SERVICE BULLETIN SB1325

ADDRESSEES	: Owners and operators of coaches listed under "Application"
VEHICLE MODEL	: CX35, CX45
SYSTEM/SUBSYSTEM	: 10.06 Exterior lighting and signaling devices – turn signals
BULLETIN TYPE	: Field Change Program
DATE	: August 25th, 2016
SUBJECT	: To modify front turn signal lamps installation
TERMS & CONDITIONS	: Refer to the warranty section further in this Bulletin

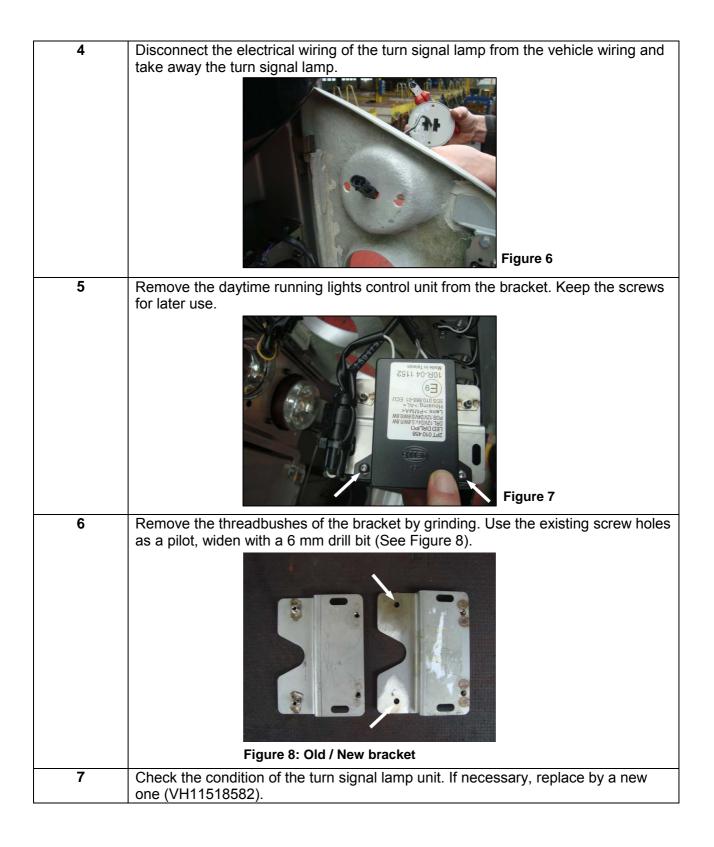
Step	Action
1	Remove the protective cap screw.
	Figure 3
2	Swing open the protective cap.
	Figure 4
3	Remove the two screws holding the turn signal lamp to the bracket at the back side of the protective cap.
	Figure 5
